SUBJECT: Forwards response to NRC questions re effects of emergency power overfrequency on Units 1, 2 & 3.

Subject: Oconee Nuclear Station
Docket Nos. 50-269, -270, -287
Response to NRC questions on Technical Specification 4.6
Revision

REQUEST FOR INFORMATION
OCONEE NUCLEAR STATION - UNITS 1, 2, AND 3
KEOWEE OVERSPEED CONDITION FOLLOWING A LOAD REJECTION

FIGURE J2

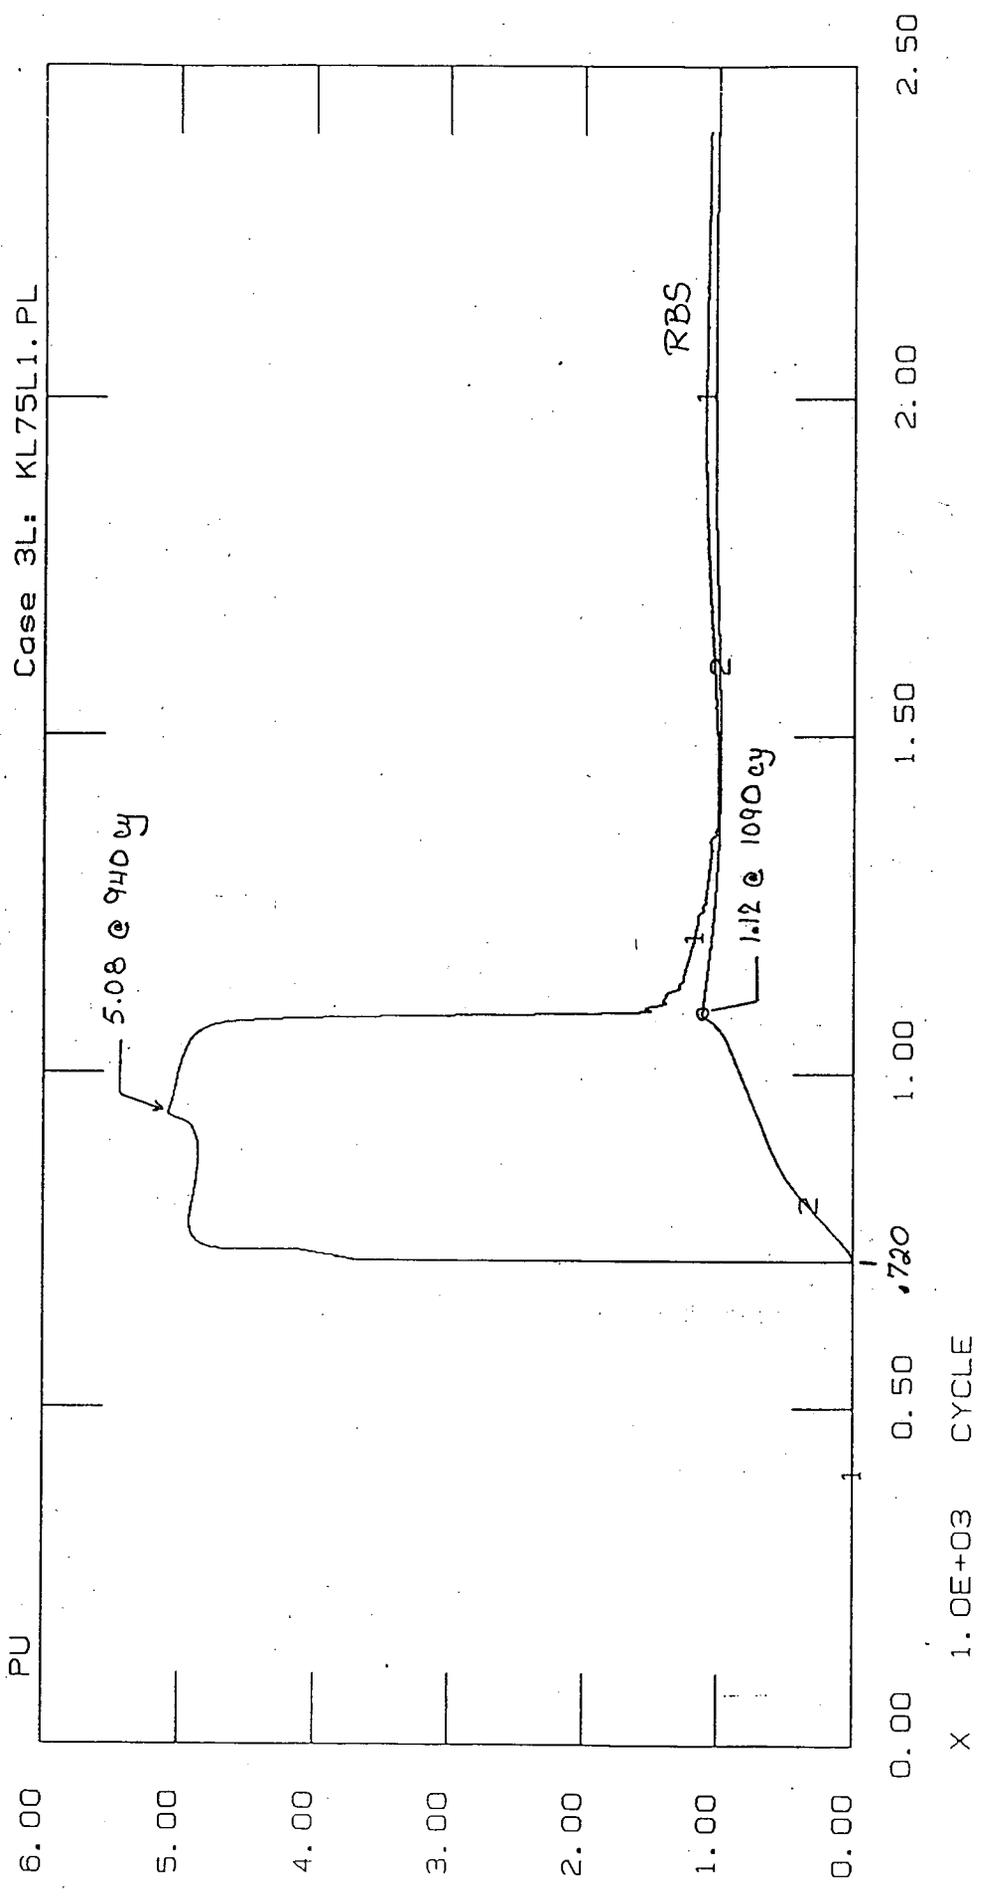
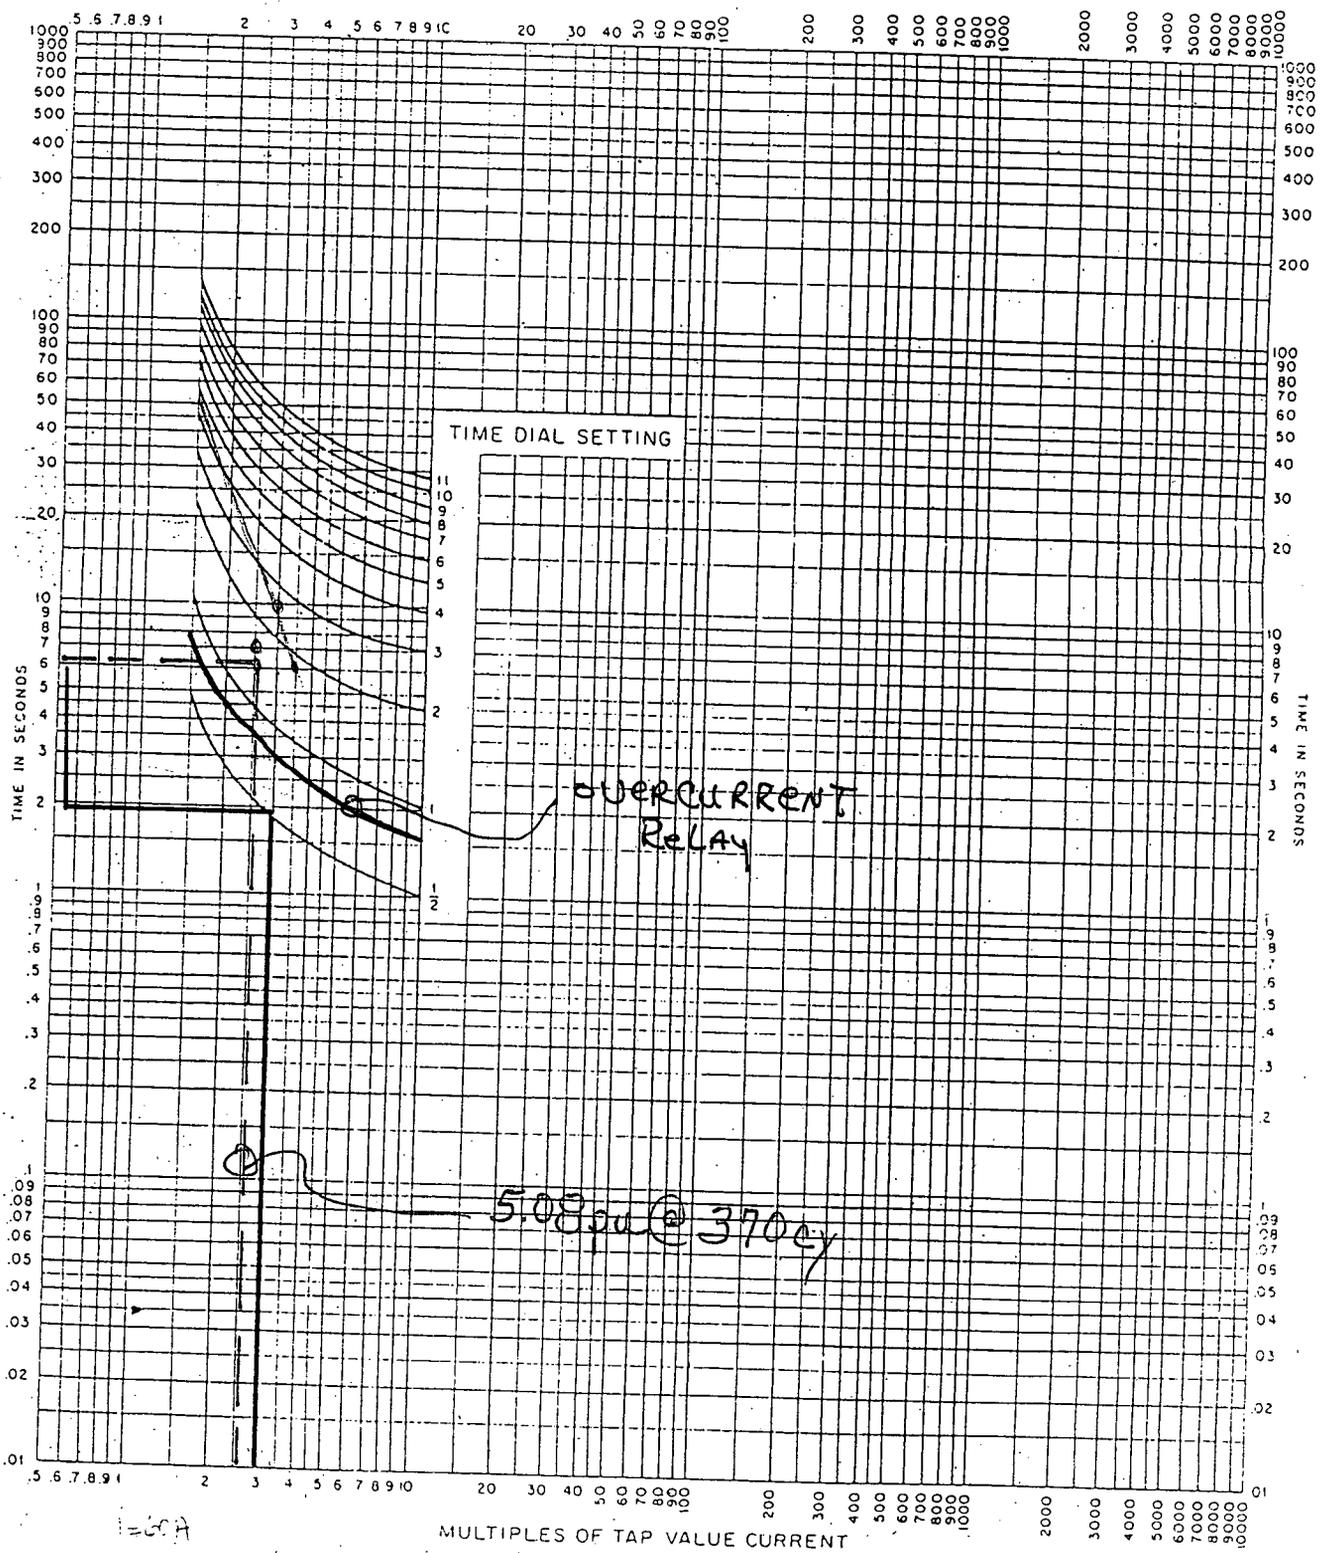
Question - Please provide a detailed discussion of the effect of frequency and voltage of the electrical power supplied by Keowee to safety-related motors (e.g., ECCS motors) and protective relays during an overspeed/overfrequency scenario as described in LER 268/93-01, Revision 1. The discussion should describe the exact sequence of events during a postulated overspeed/overfrequency scenario and discuss acceptable voltage and frequency ranges for the power supplied by the Keowee units which ensure ESF systems will function as intended. In your response, please discuss any administrative controls or limits regarding the normal mode operation of the Keowee units needed to ensure the time requirements contained in applicable accident analyses are met. This discussion of a postulated overspeed/overfrequency scenario should include and make reference to any pertinent calculation, analyses, and/or evaluations performed to support your assumptions and conclusions.

Attachments 1 and 2 further explain and support the above information. Attachment 1 shows the expected reactor building spray motor starting curve during the over frequency period and the over current device actuation [Reference 2]. Attachment 2 shows frequency and voltage plots vs. time for a Keowee unit during a load rejection scenario [Reference 4].

The following plot (Figure J2) originated from OSC-5701, "OCONEE/KEOWEE OVERHEAD PATH ANALYSIS", Case 3L. This case was simulated for the scenario where the LOCA unit would be to the underground path 11 seconds following the event. The overhead path circuit was used to simulate this case because the underground circuit was not yet created (in the CYME model) and the results from the overhead circuit should be a good indicator as how the underground Unit would perform. At 11 seconds following a 75MW load rejection with a net head of 113', the frequency of the underground unit would be the same as the overhead unit. As a result some of the safety motors are expected to trip on overcurrent. The following plot (figure J2 in Appendix J) shows the starting current and time for the RBS pump motor, 5.08 pu for 370 cy. Based on the overcurrent relay setting also provided, this motor is expected to trip. Therefore, this case is not acceptable.

Voltage and Frequency vs. Time Plots

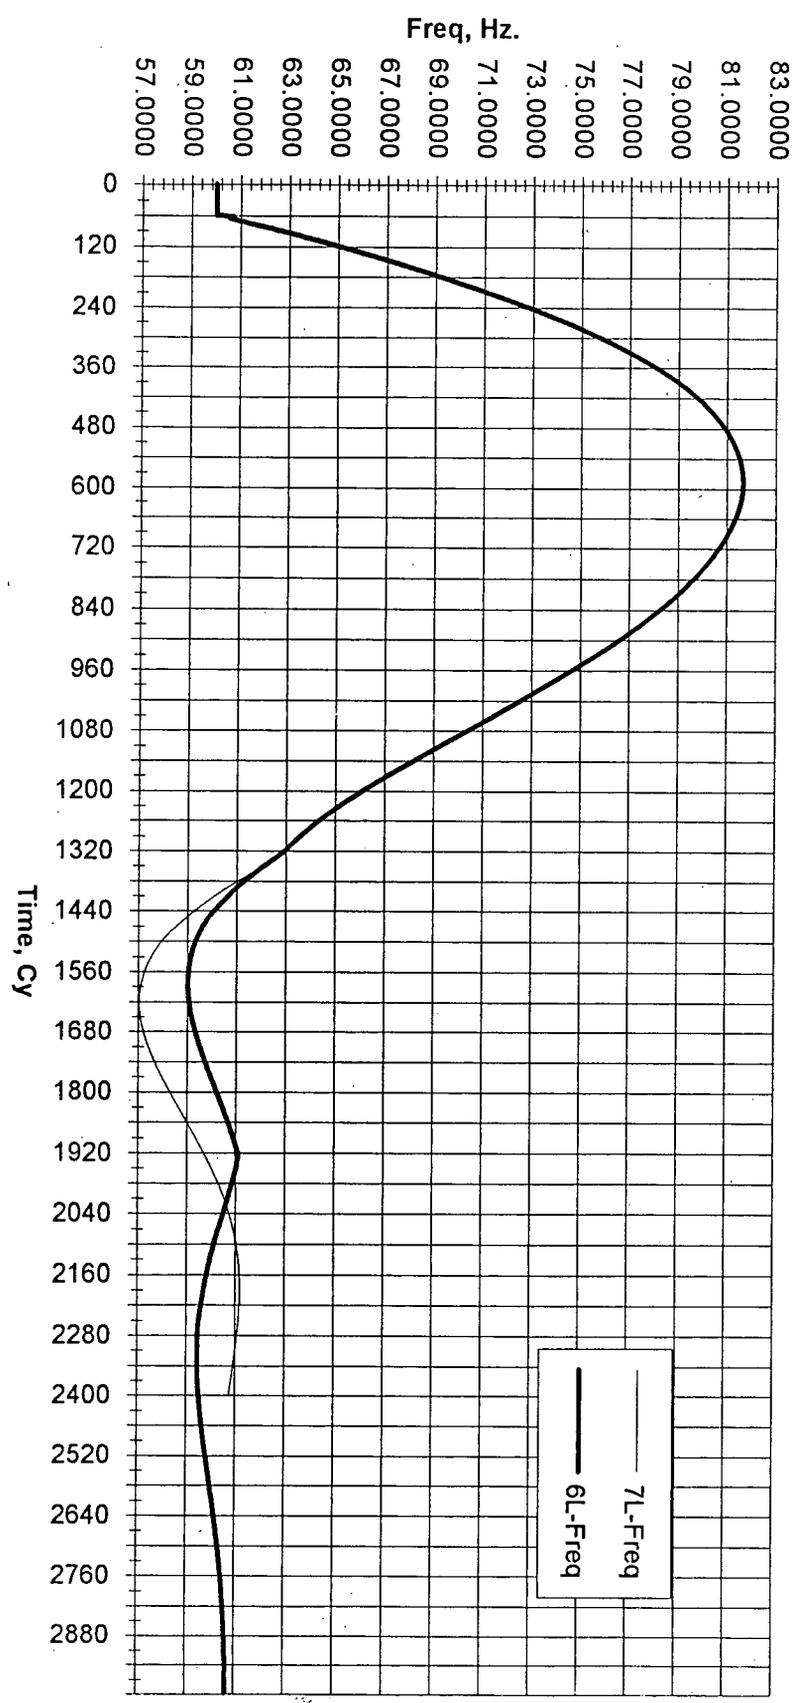
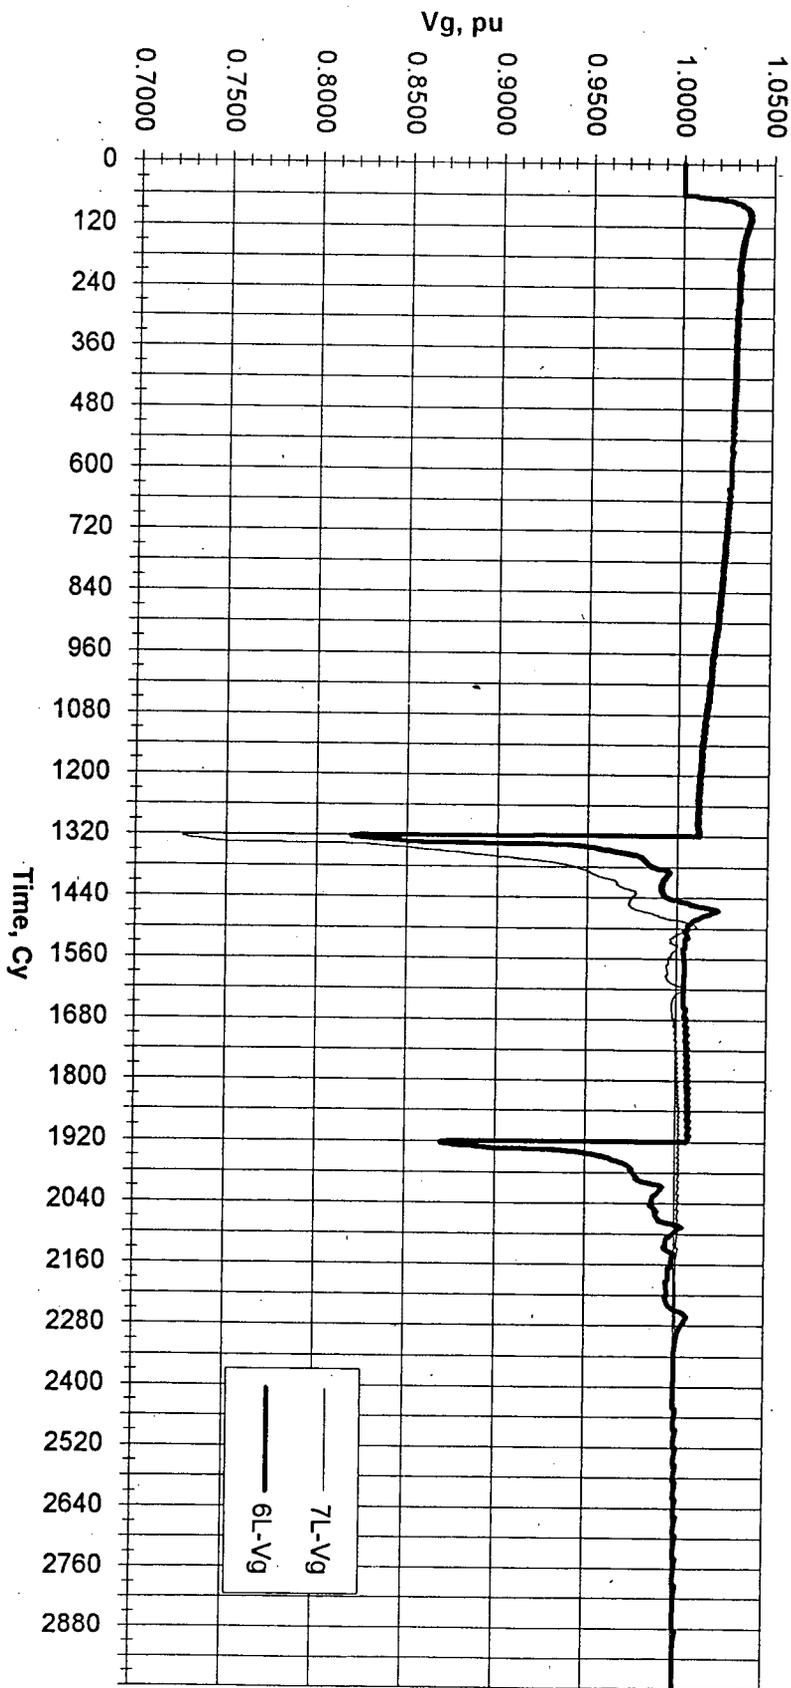
Please provide frequency and voltage plots vs. time for the power supplied by the Keowee units during a postulated overspeed/overfrequency scenario and any sensitivity studies conducted to show how frequency and voltage change with different lake levels or different power output levels of the Keowee units. Also, please provide any calculations performed to determine maximum and minimum lake levels for Keowee normal mode operations and the maximum Keowee power output levels permitted at these lake levels to ensure the time requirements contained in applicable accident analyses are met.

Case 6L simulates the Keowee overhead unit, with a net head of 113', rejecting 75MW of load at t=60 cy, and then accepting Oconee load in two steps. The first step at t=1320 cy, 21 seconds following load rejection, the startup bus is energized (see results of case 2L). At this time, the LOCA unit has already transferred to the Underground Unit, and only the LOOP units would be connected to the overhead path. Ten (10) seconds later, t=1920 cy, if the underground circuit failed for any reason, the LOCA unit would transfer back to the startup bus. This re-transfer constitutes the second step for Case 6L.

Case 7L simulates the Keowee overhead unit, with a net head of 113', rejecting 75MW of load at t=60 cy, and then accepting Oconee load at t=1320 cy when the startup bus is energized 21 seconds following load rejection (see results of case 2L). Oconee loads consist of Oconee unit 1 LOCA loads plus the largest unscheduled motor load and Oconee unit 2 & 3 LOOP loads.
